## **Technical Service Information**

## THM 440-T4 UPPER CHANNEL PLATE GASKET CONNECTED

88-37 Page 1 of 1

Figure 1

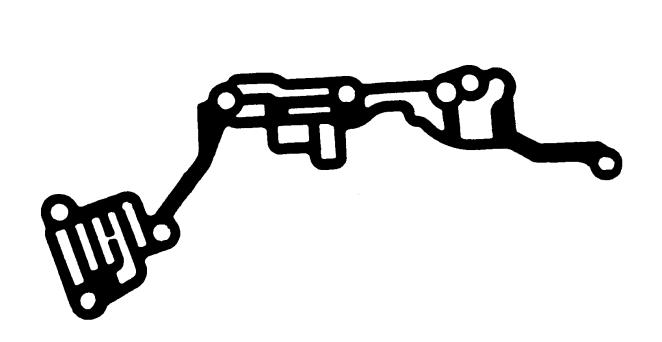
There has been a new Upper Channel Plate Gasket released that connects the modulator port gasket and upper channel plate gasket together. This change was implemented to help prevent misassembly of the gaskets during the assembly process (See Figure 1).

The new upper channel plate gasket will retro fit back to 85 1/2 hydraulics only, because of the absence of one dam in the gasket. The previous design gaskets may still be used.

SPECIAL NOTE: DO NOT USE THE NEW GASKET ON 1985 HYDRAULICS.

DO NOT USE ON 1985 HYDRAULICS TRANSAXLES
